Access Compliance Report

Public Rights-of-Way

Intersection ID: 49321	Main Street: WHITEBEAM_WY	Cross Street: HUNTERS_MOON_LN	Location: NW
ADA ID: 14C34405402A	Ramp Type: BlendTrans1	Initial Pass/Fail: Fail	Overall Compliance: No
		Severity Score: 12.5

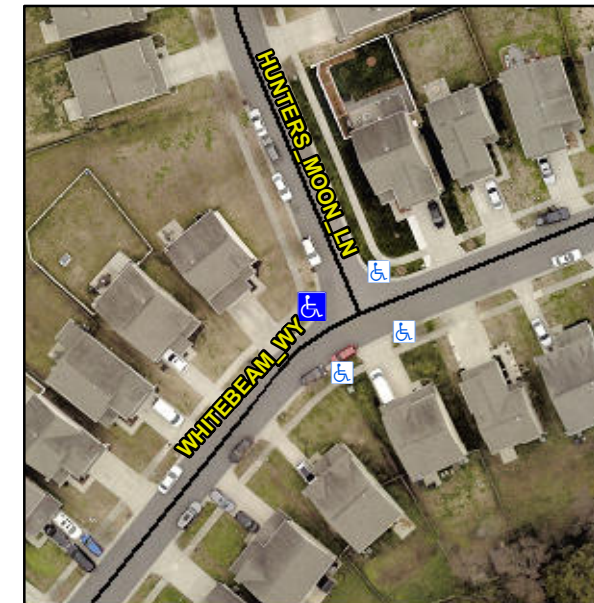
R304.5.3

Compliance	Description	Data	Compliance	Description	Data
N/A	Ramp Length (in)	72.0	Yes	BlendTrans Slope (%)	2.5
Yes	Ramp Width (in)	49.0	No	BlendTrans XSlope (%)	5.3
N/A	Flare Type LT	N/A	N/A	Flare Type RT	N/A
N/A	Flare Slope LT (%)	N/A	N/A	Flare Slope RT (%)	N/A
N/A	Flare Traversable LT?	N/A	N/A	Flare Traversable RT?	N/A
N/A	Landing Length (in)	N/A	N/A	DWS Provided?	N/A
N/A	Landing Width (in)	N/A	N/A	DWS Contrast?	N/A
N/A	Landing Slope (%)	N/A	N/A	DWS Length (in)	N/A
N/A	Landing X Slope (%)	N/A	N/A	DWS Full Width?	N/A
N/A	Landing Curb? (Y/N)	N/A	N/A	DWS Offset (in)	N/A
N/A	Shared Landing?	N/A			
N/A	Gutter Ponding?	N/A	N/A	Gutter Slope (%)	N/A
N/A	Gutter Lip Ht (in)	N/A	N/A	Gutter X Slope (%)	N/A
N/A	Painted X Walk1?	No	N/A	Painted X Walk2?	No
	X Walk 1 Direction	To SE		X Walk 2 Direction	To NE
	X Walk 1 Width (in)	N/A		X Walk 2 Width (in)	N/A
	X Walk 1 Slope (%)	3.0		X Walk 2 Slope (%)	3.2
	X Walk 1 X Slope (%)	4.4		X Walk 2 X Slope (%)	5.1

Remove & Replace Curb Ramp With Two New Directional Ramps or Equivalent.
